**CITY OF BATON ROUGE
PARISH OF EAST BATON ROUGE**

ADDENDUM NO. 4

**SUBJECT: GROOM ROAD (McHugh Road – Plank Road) PROJECT
CITY-PARISH PROJECT NO. 19-EN-HC-0035**

SHEET NUMBER	2b
PARISH	EAST BATON ROUGE PARISH
QTY PROJECT	19-EN-HC-0035
STATE PROJECT	
DATE	MAY 2025
SHEET	3 OF 5
DESIGNED	JAC
CHECKED	TAA
DETAILED	GPT
CHECKED	JAC
REVISION	
DATE	06/2025
NO.	0
REVISION DESCRIPTION	
BY	
DETAILS	
GROOM ROAD - LA 19 TO PLANK ROAD	
BR	
PEC

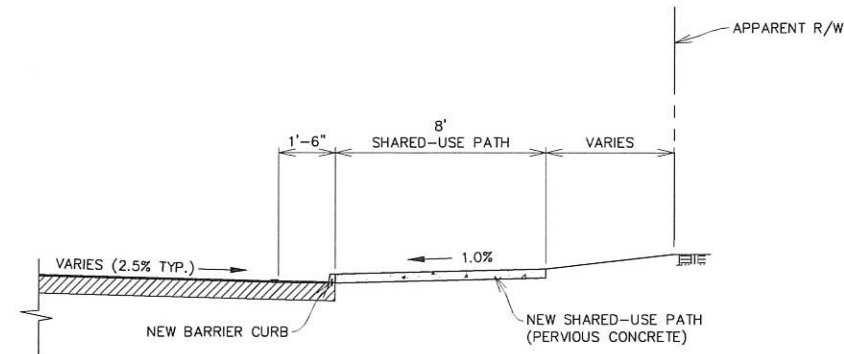
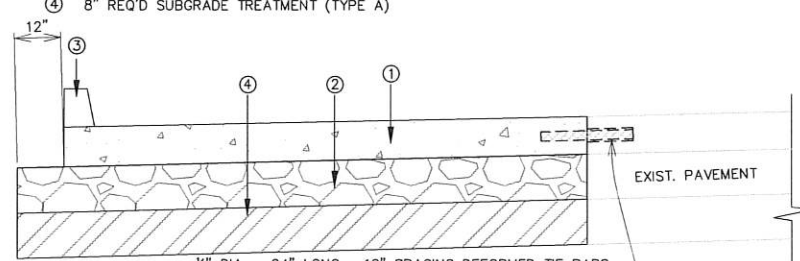
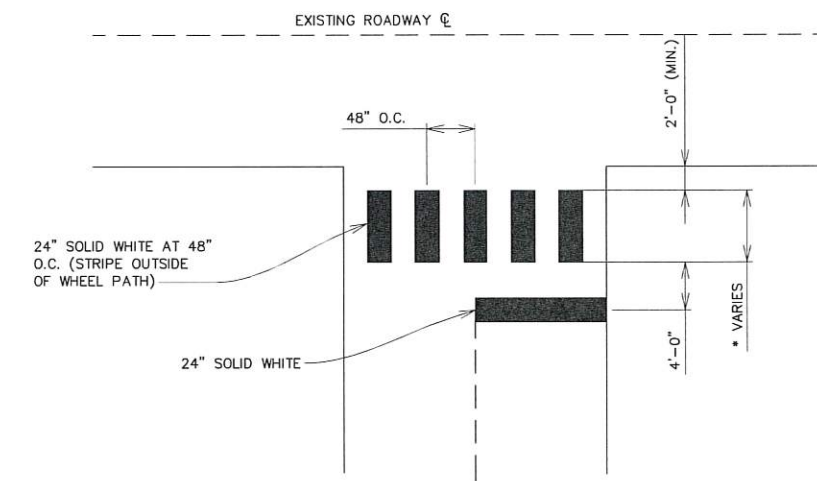
1. **I received a call from an asphalt subcontractor this afternoon questioning where item 9900031 Binder Course was to be used on the project. There is a note in the plans that calls for a leveling course, but the note states a Level 2f is to be used, not the Binder. Please advise?**

Please delete sheets 2, 2b, 2c, and replace with Revised (Revision #1) Sheets 2, 2b, 2c.
